memorandum

to Lennie Roberts (Committee for Green Foothills)

from Louis White, PE

subject Valleymar Bluffs Coastal Hazards Assessment: Estimate of Accelerated Bluff Erosion due to Sea Level Rise (ESA Ref. #D160715.00)

Figure 14

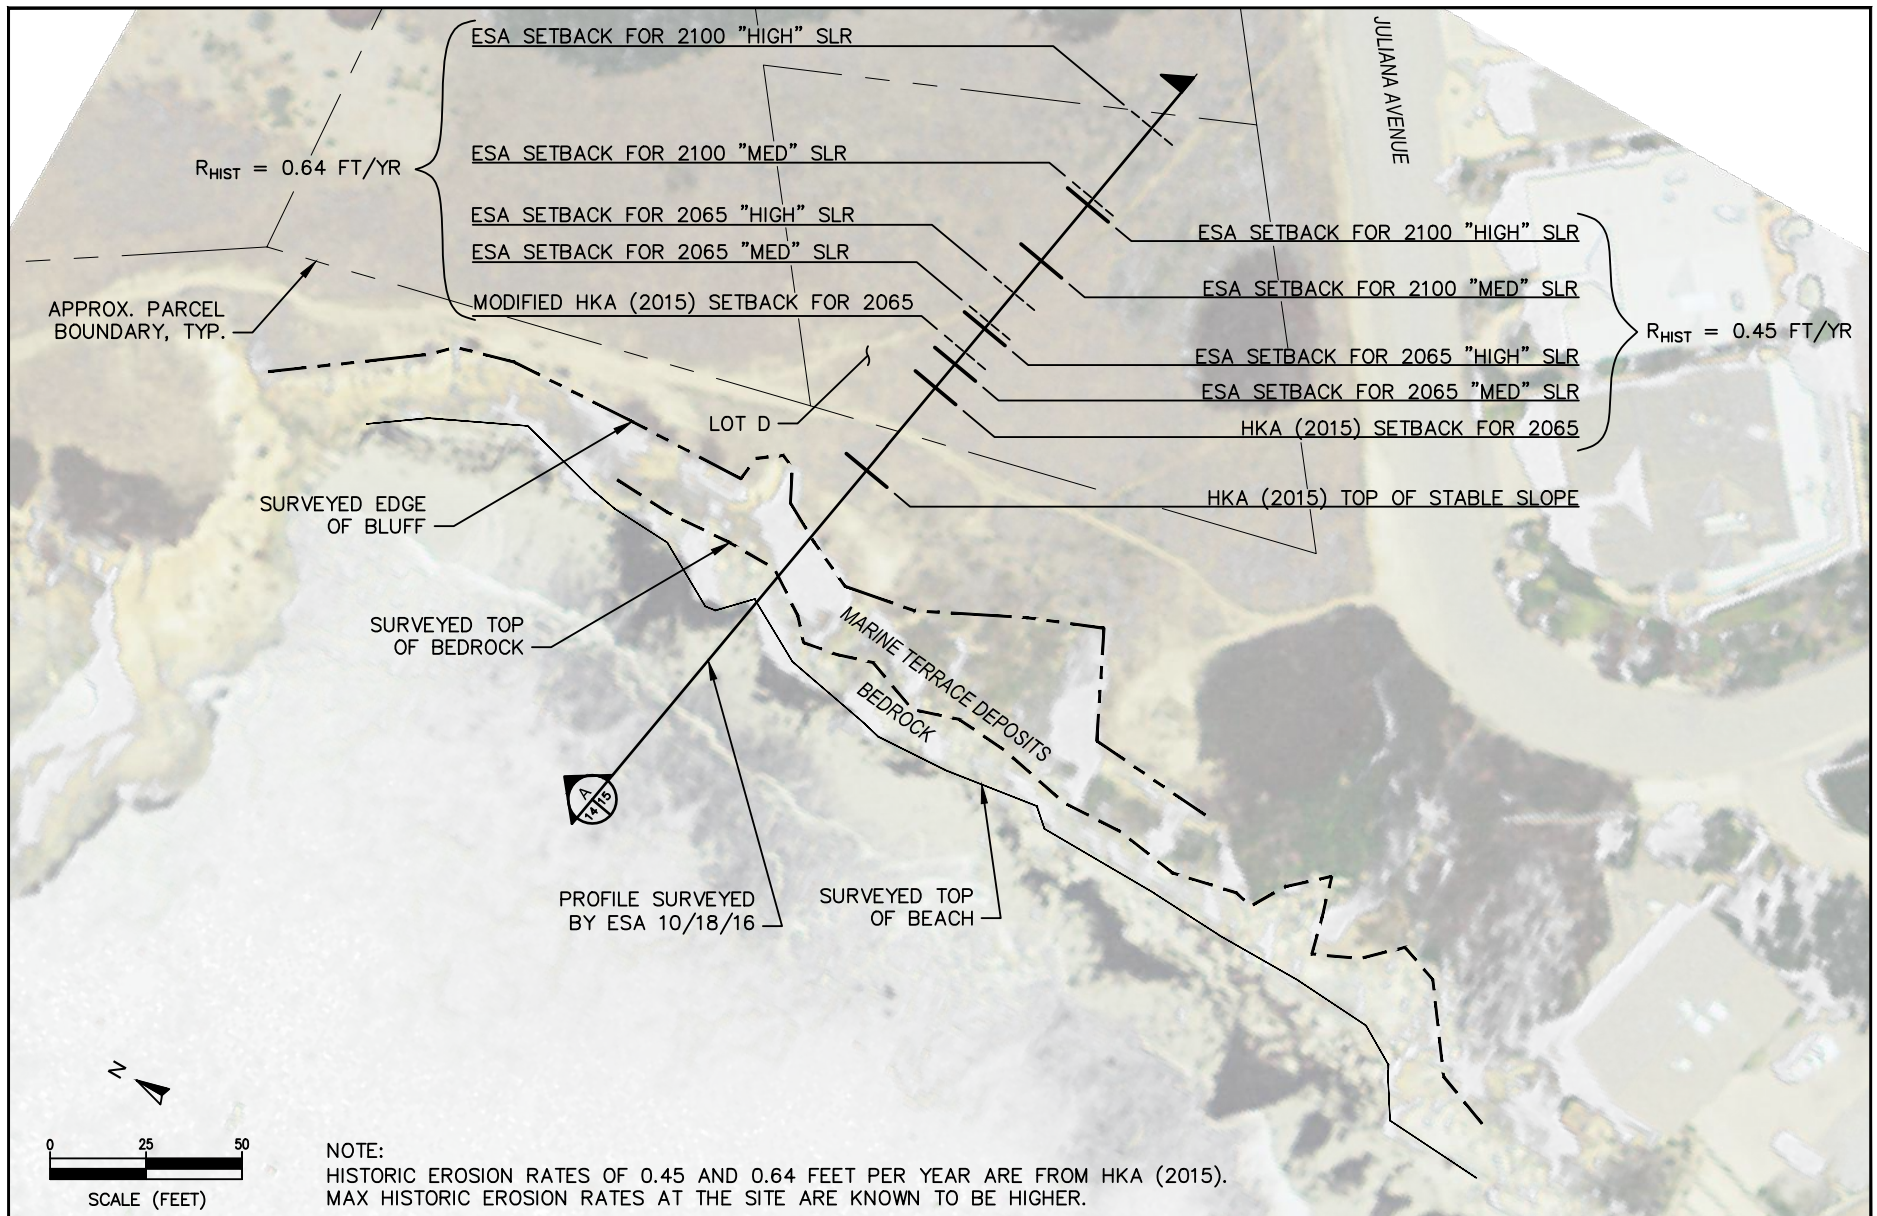
Figure 14 presents a plan view of the stable slope location and the computed setbacks associated with the medium and high SLR scenarios at 2065 and 2100 for two historic erosion rates. The setbacks shown with the solid lines are based on a historic erosion rate of 0.45 feet per year, and those with the dashed line are based on a historic erosion rate of 0.64 feet per year. These setback distances are applicable to the surveyed profile location only, and may not be representative of appropriate setback distances along the shore. Additional work is required to

As shown in Figure 14, we expect a greater amount of erosion to occur by 2065 as compared to the results of HKA (2015). Because of the uncertainty and sensitivity of the historic erosion rate estimated by HKA (2015), we recommend incorporating a factor of safety or use a higher rate. As shown by our results, a relatively small increase in the historic erosion rate resulted in a greater amount of future erosion and larger setback distances. Although this analysis is not intended for locating structures, our findings indicate that a greater amount of erosion should be considered in the proposed project to avoid potential future hazards.

- Incorporate a factor of safety into the setback distance calculation, or use a higher historic erosion rate.
- Consideration of the erosion gullies is important in assessing the potential hazards at Lot D. The gullies may not behave according to the historic erosion rate, and the presence of fill and concrete debris suggests that a landslide may be deeper than perceived from visual inspection. The potential migration of the gully into Lot D should be assessed in greater detail. Further study should assess whether the gully identified previously as a landslide would be considered active.
